Re: Petition No. 1195 – SolarCity Corporation petition for a declaratory ruling that no Certificate of Environmental Compatibility and Public Need is required for the proposed construction and operation of a 4.05 Megawatt Community Shared Solar Photovoltaic Electric Generating facility located on municipally-owned property at 1240 Poquonnock Road, Groton, Connecticut -- Response to Interrogatories - Set 2

Re: Petition No. 1195-- SolarCity Corporation Responses to Connecticut Siting Council interrogatories- Set 2

WATER QUALITY SWALE CHECK DAM DETAIL

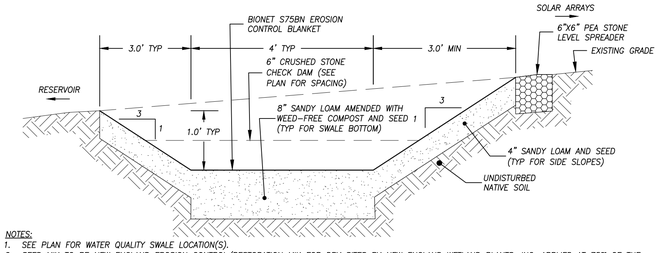
Additionally, as part of the DPH Permit submittal, SolarCity is proposing to install a series of perimeter water quality swales between the limits of the proposed arrays and the reservoir to further mitigate any potential runoff impacts to the adjacent resource areas. The water quality swales will be populated with local plant species consistent with those already present in wetlands in the immediate vicinity. Revised plans are attached to this response showing the location, cross-sections and planting detail associated with the newly proposed water quality swales (Attachment 1).

WATER QUALITY SWALE DETAIL

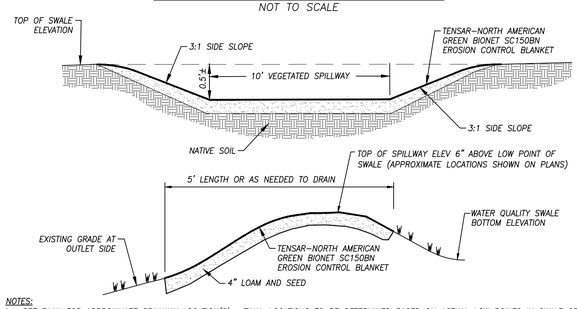
c) **Specifically, which measures have been incorporated into the design of the project to protect water resources?**

NOTES:
1. SEE PLAN FOR WATER QUALITY SWALE LOCATION(S).
2. SEED MIX TO BE NEW ENGLAND EROSION CONTROL/RESTORATION MIX FOR DRY SITES BY NEW ENGLAND WETLAND PLANTS, INC. APPLIED AT 75% OF THE MANUFACTURER'S RECOMMENDED APPLICATION RATE AND NEW ENGLAND CONSERVATION/WILDLIFE MIX BY NEW ENGLAND WETLAND PLANTS, INC. APPLIED AT 50% OF THE MANUFACTURER'S RECOMMENDED APPLICATION RATE.
3. STRIP TOPSOIL FROM WATER QUALITY SWALE AREA; AMEND WITH WEED-FREE COMPOST (30% TO 40% BY VOLUME) TO PROVIDE SOIL MEDIA FOR WATER QUALITY SWALE BASE; EXCAVATE FROM EXISTING GRADE; LOAM, SEED AND STABILIZE WITH TENSAR-NORTH AMERICAN GREEN BIONET S75BN EROSION CONTROL BLANKET.
4. EROSION CONTROL BLANKET TO BE INSTALLED IN ACCORDANCE WITH MANUFACTURER'S REQUIREMENTS.

TREE PLANTING DETAIL

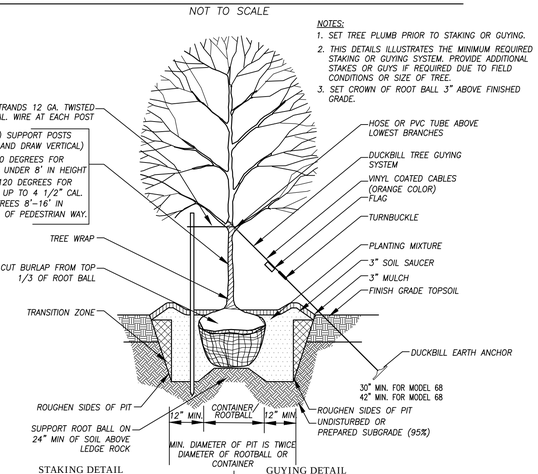
b) **Has SolarCity considered adding additional landscaping along the southeast border of the facility to further buffer the facility from the adjacent residential area?**

Response: A vegetative buffer will be installed just outside the existing southern fence line as requested by the Planning Commission. Revised plans are attached showing this buffer and associated planting details (Attachment 1).
